Errata disclaimer: This Errata applies to SLG46531 revision XB.

## ISSUE 1: Counter Incorrect Operation after the Reset

## ISSUE 2: FILTER cell does not filter out glitches

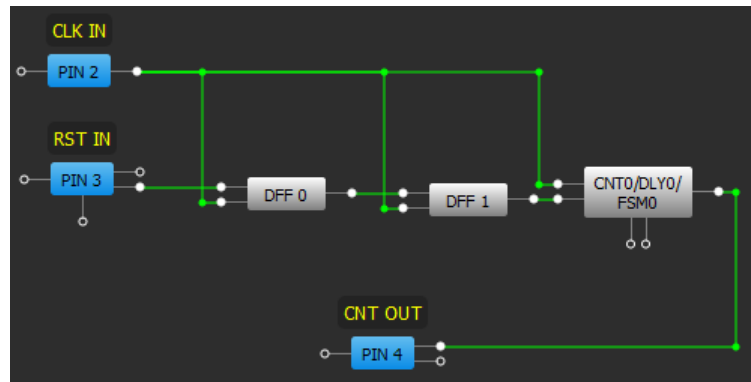
If the Counter Reset is asserted at the same time as a rising clock edge, it is possible that the Counter Data will be reset incorrectly and the counter output may appear faster than expected. This phenomenon appears more often as the clock frequency increases.

- Synchronize RESET input of the Counter with its CLK using 2 DFF cells as shown on picture below.

Channel 1 (yellow/top line) – PIN#4 (IN)  
Channel 2 (light blue/2nd line) – PIN#10 (OUT)  
Channel 3 (magenta /3rd line) – PIN#12 (DFF)

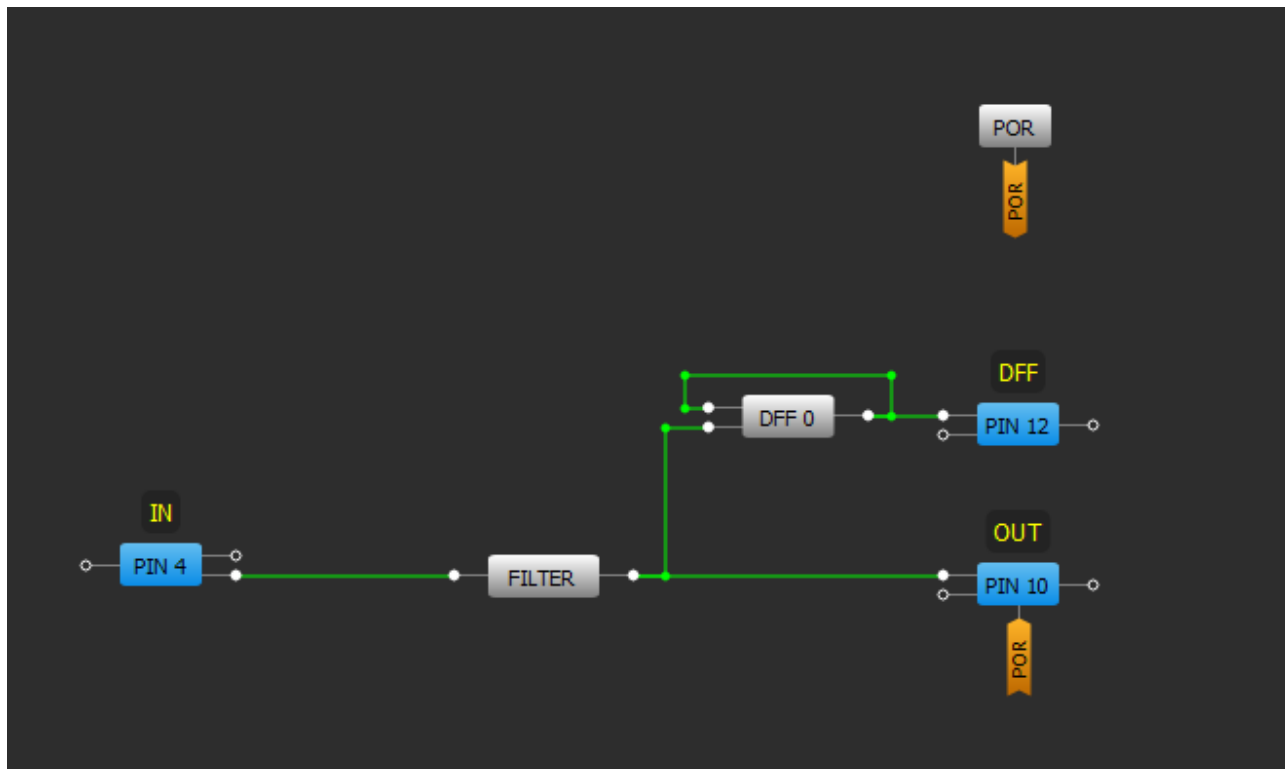
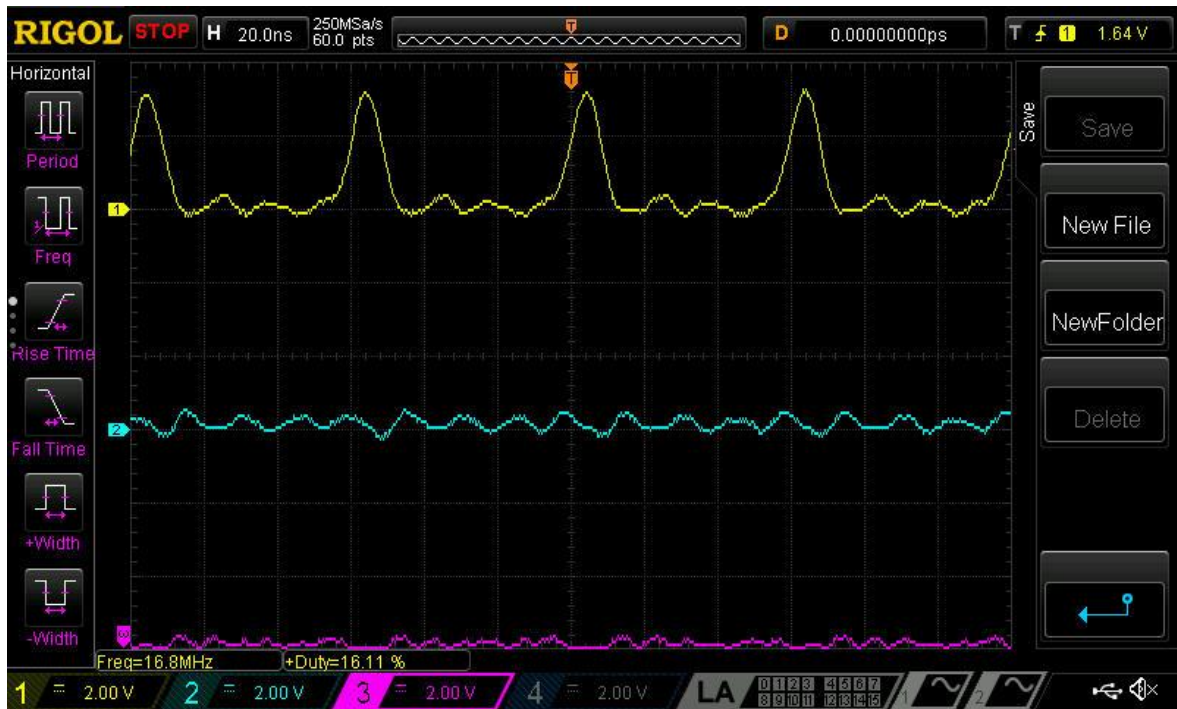
If clock type high frequency input comes in, the FILTER cell may not filter out it. There are several factors like input frequency, duty cycle and LOW duration in such signal that may lead to its passing through FILTER block.

1. Period is 60ns. Pulse width is 10ns DC=16.7% (Correct functionality)

2. Period is 60ns. Pulse width is 20ns DC = 33.3% (Incorrect functionality)

3. Period is 60ns. Pulse width is 30ns DC=50% (Incorrect functionality)

4. Period is 60ns. Pulse width is 40ns DC=66.67% (Correct functionality)

Currently there is no workaround for this issue. Filter block is good at filtering short spontaneous glitches. It is intended to be used in series connection before the delay cell to avoid its latching (see issue #2).
